From: Jeanne Boatwright <jeanne@boatwrightengr.com>
Sent: Friday, May 28, 2021 5:02 PM
To: Angela Clegg; lmscustomhomesllc@gmail.com
Subject: RE: SDC's and lot frontage requirements
Attachments: Foothills Ridge Plat B rev 5-26-2021.pdf; Foothill Ridge set2.pdf

FOOTHILLS RIDGE SUBDIVISION

Staff Report Presented to the Planning Commission

FILE NUMBER: SD21-01

STREET INFORMATION

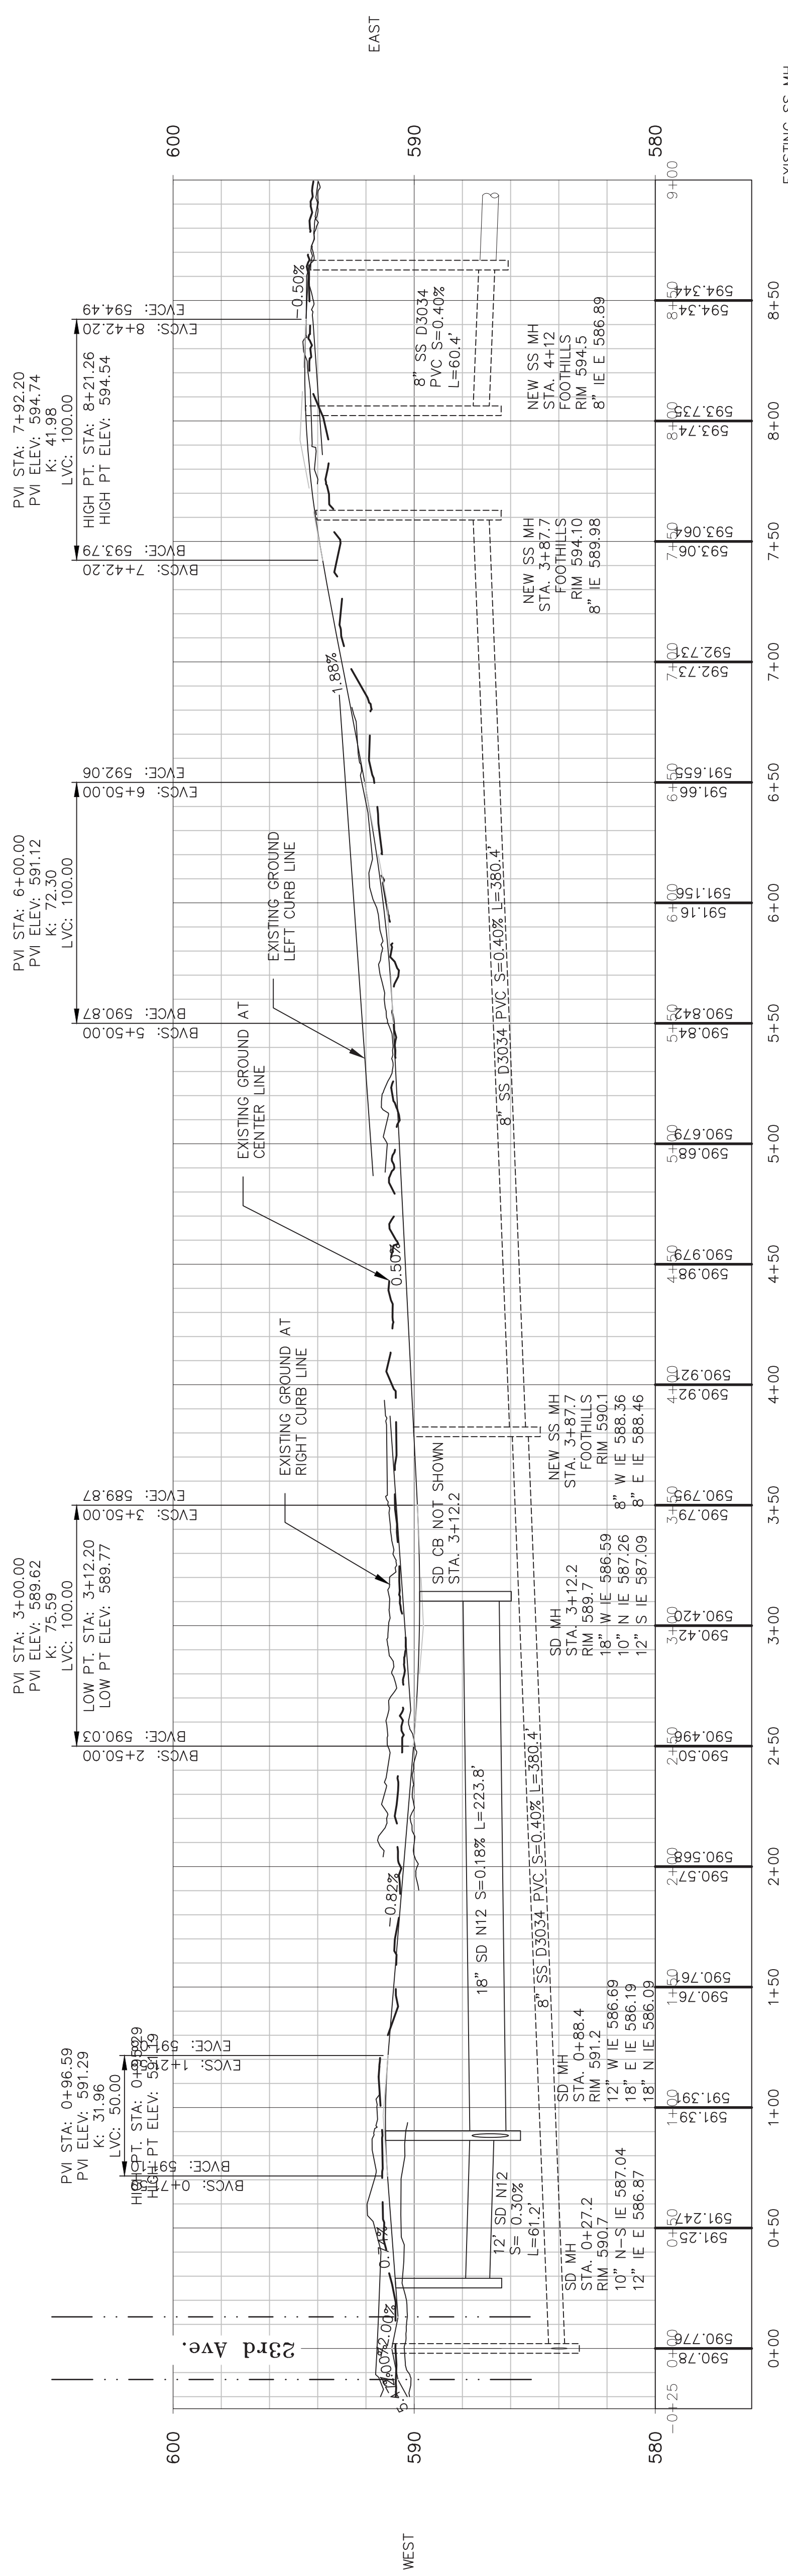
The TSP roadway dimensions require a minimum 3-foot planter strip for Local Streets which the narrative and plan do not show. Foothills Drive is wide enough for planter strips to be constructed and are required. The proposal shows a 50-foot right-of-way, which provides adequate width for 5 feet sidewalk, 4 feet planter, and 30-foot curb to curb widths which provides the minimum 7 feet parking and travel lanes, etc. However, 23rd Avenue is only 40 feet wide with some portions at 35-foot-wide, the planter strips are not required, and sidewalks can be curbside.

The Fire & Ambulance District is requiring that the NE corner of Foothills Drive and 23rd Ave be a rounded corner with a 20-foot radius, to facilitate turning of large vehicles. The properties on the south boundary accessed by easement do not indicate if the front residences will or will not connect to that shared driveway. If they do then each driveway will have four residences, lessening the number of driveway aprons to Foothills Drive itself. However, it may create some issues with emergency services and access to those residences.

TRANSITION FROM 60' ROW ON EAST END

CURB TO CURB WIDTH 30'

TYPE A CURB TO HAVE 5% PAIN SLOPE
4' LANDSCAPE STRIP BETWEEN CURB & SIDEWALK

CURB RADIUS AT CORNER OF 23RD AVENUE 20 FEET

SOUTH BACK LOTS TO SHARE 22' COMMON DRIVEWAY

SPLIT CULVERT

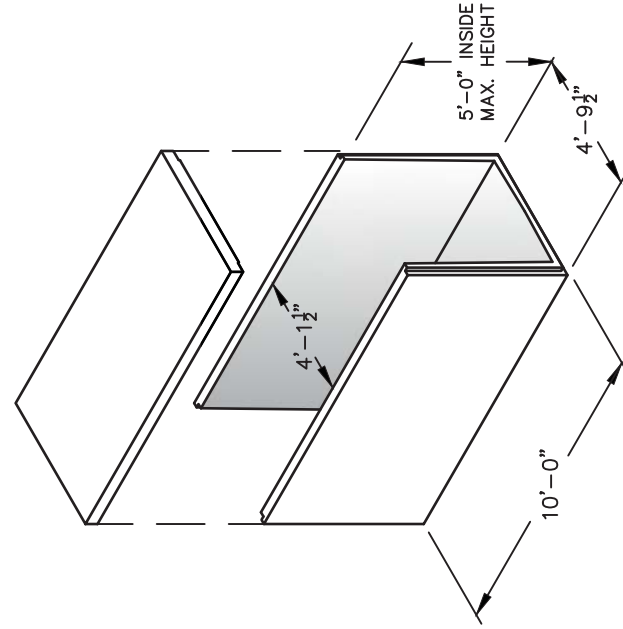
This development will need to link the proposed water system on Foothills Drive to Harding Street. 23rd Avenue had a very small waterline that was inadequate to connect to. However, city water crews have recently removed that work item from the subdivision requirements with our replacement in April 2021 of that waterline. The city has placed 250 foot of 6" waterline in 23rd Avenue from the Harding Street 6" waterline southward to a few feet from the drainage channel culvert. The city has done this work for our own distribution system needs; the developer would have had to do this otherwise. This proposed subdivision shall connect at the new end point now, with a crossing under the channel. The channel culvert currently has only 6"-8" of cover.

REPLACE 36" CMP = 7.0 SF
WITH OPEN BOTTOM CULVERT
INSIDE 4.13'x2'± = 8.25SF
